To: Kristopher Byrd, Well Construction and Compliance Section Manager
From: Travis Kelly, Well Construction Program Coordinator
Subject: Review of Water Right Application G-18947
Date: June 1, 2021

Groundwater Application Review Summary Form

Application # G- 18947

Well Location Map

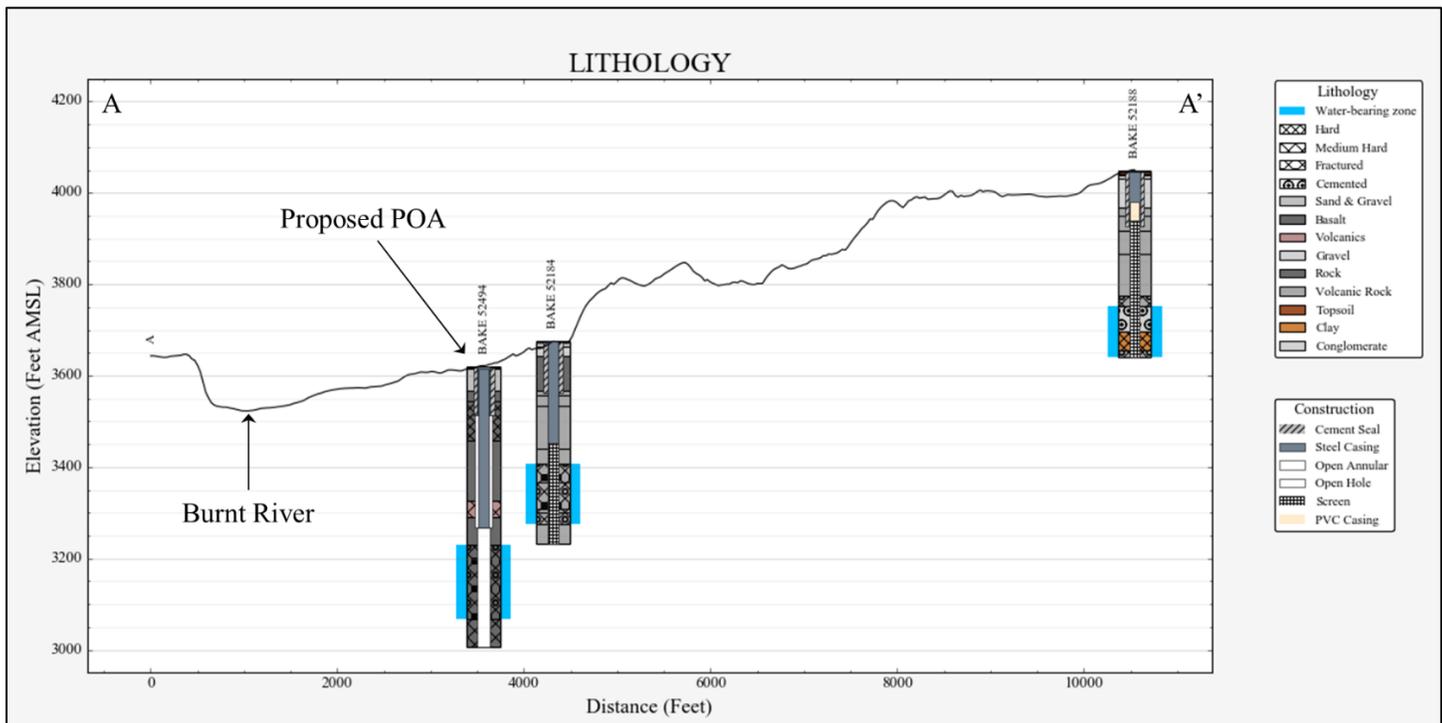
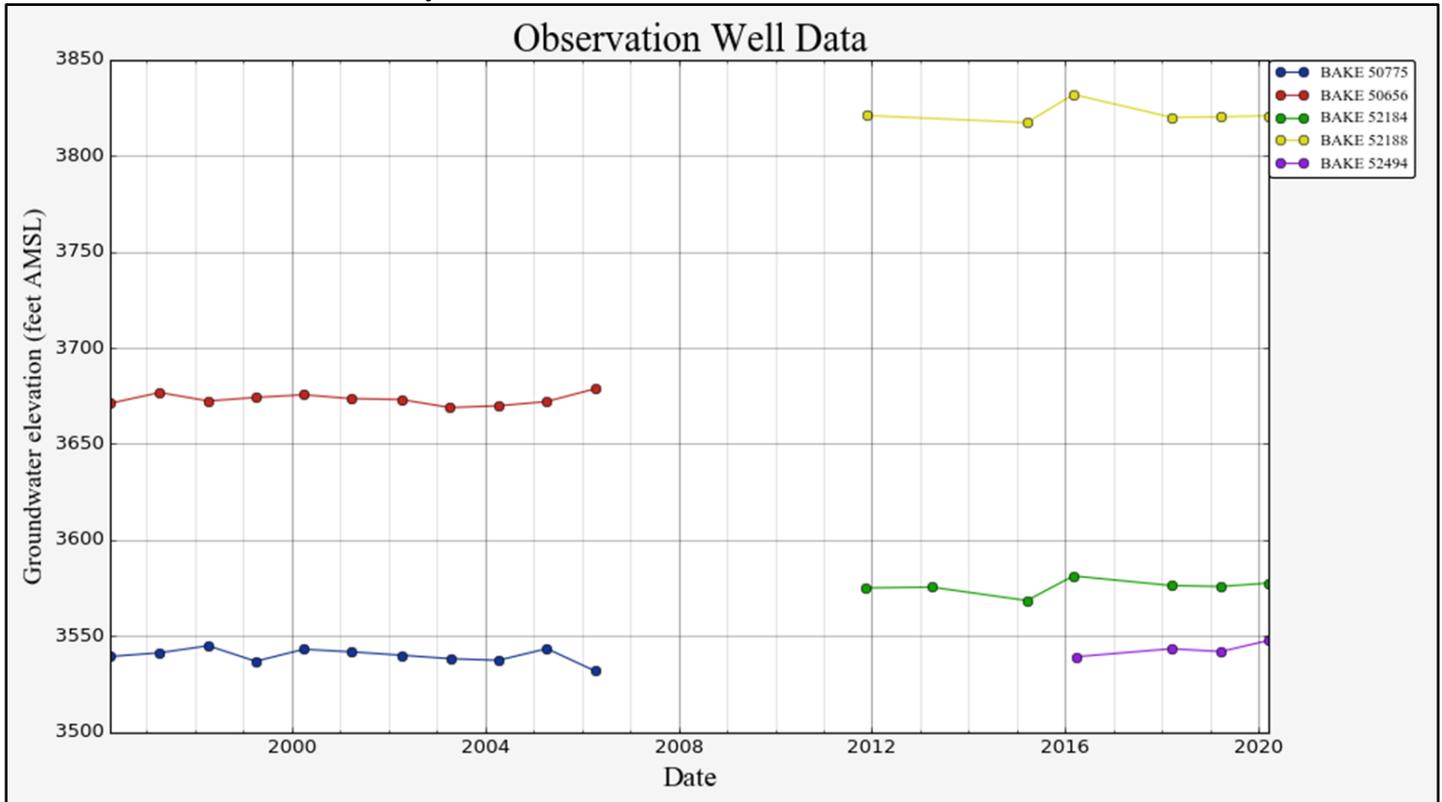
Basis for aquifer hydraulic connection evaluation: Local reaches of Pine Creek and Burnt River are denoted as intermittent streams on USGS topo maps, suggesting that flow within these reaches depends on surface water runoff and shallow baseflow. The water-bearing zones accessed by the proposed POA well are unlikely to have an efficient connection to these streams within one mile.

Occurrence of fractured rock coincident with water-bearing zones within local wells are reported at lower elevations toward the south. The southern-dipping lithologies (Evans, 1993) are conceived to provide a barrier to vertical migration of groundwater beneath Pine Creek (parallel to cross-section) and the Burnt River.

Cross section modified from Evans (1993) roughly parallels well fence diagram above, showing map units in this area dipping toward the south and cut by several faults (Tb: Miocene basalts, Tt2: Welded lapilli tuff, Td13: Rhyolite flows, Td8: Welded lapilli ash flow tuff, Trbs: Triassic Metasedimentary rocks). Our conceptual model assumes these units continue to descend beneath the Burnt River valley to the south.

Water-Level Measurements in Nearby Wells

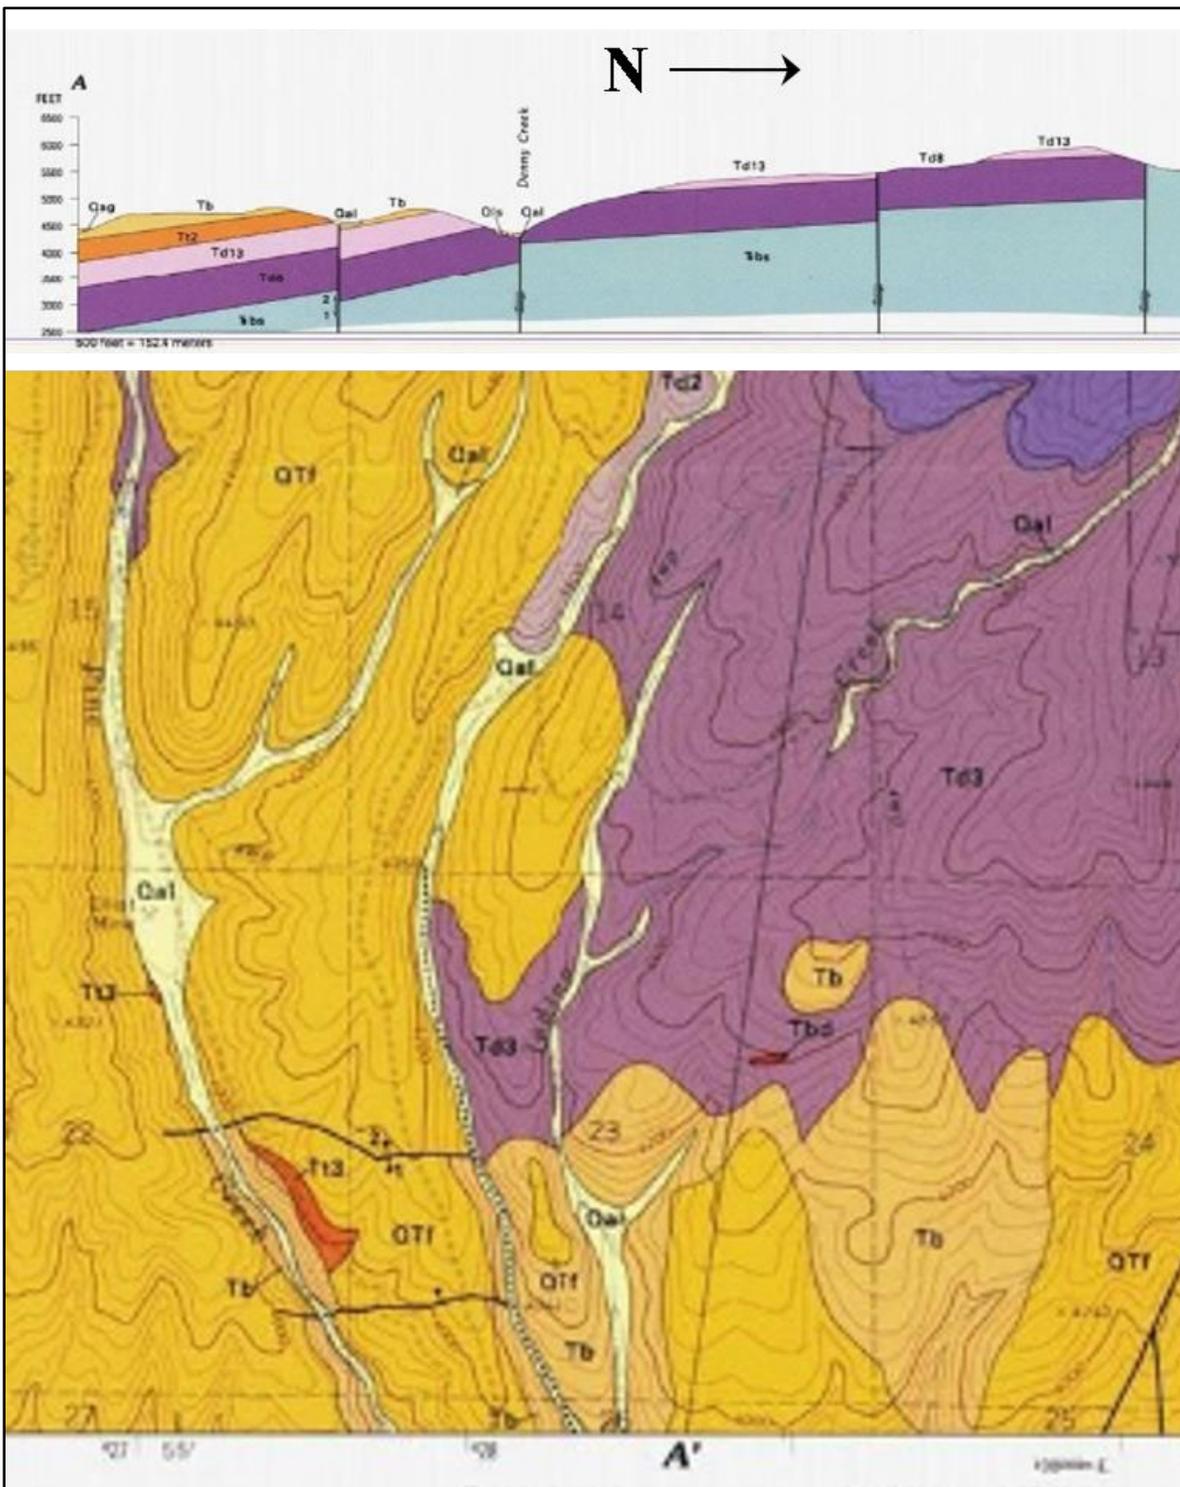
B3. **Groundwater availability remarks:** Available groundwater data suggest water levels in the productive aquifer are stable (see attached hydrograph). There is little known production from the proposed aquifer, except previous allocation that includes the proposed POA well (permit G-16978). The reported yield of the POA well is 200 GPM (air test), matching the proposed maximum rate on this application. It is uncertain whether the existing well will support this rate, let alone additional use previously authorized under G-16978. Permit G-16978 includes a 7 year measurement condition to evaluate changes to the productive aquifer. With the proposed additional pumping, if a permit is issued it is recommended that condition 7N be added in order to establish a long-term record of water level trends to better inform further allocation requests.
